# Service Bulletin

NO. 327

## Studebaker and Packard Clipper

Fig. 1

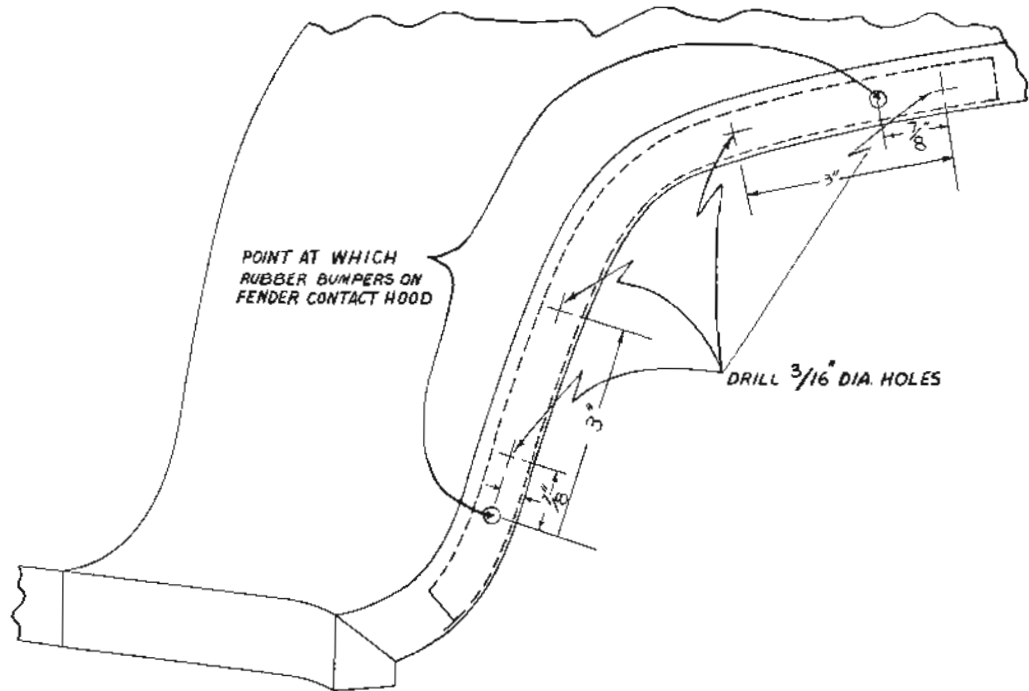
Reinforcements are now being added in production to the hoods of all sedans and station wagons. A reinforcement is located in each side flange near the front corner. Although the reinforcements are being welded in production, they may be installed in the field by using small bolts and nuts. However, a flat oval-head bolt must be used to prevent interference at the fender when the hood is closed.

Layout and center-punch the hole locations

on the hood flange to the dimensions shown in Fig. 1. Then, drill the holes with a 3/16" diameter drill. The bracket may be held in position on the flange with lock-type pliers and, the flange and bracket drilled at the same time. After installation of the bracket, check the clearance between the bolt heads and the fender. Provide clearance if necessary, by carefully striking the head of the bolt with a rubber mallet.

The following parts are required:

- 1 - 1320686 Bracket, right
- 1 - 1320687 Bracket, left
- 8 - 2055X1 Bolts
- 8 - G271166 Nuts
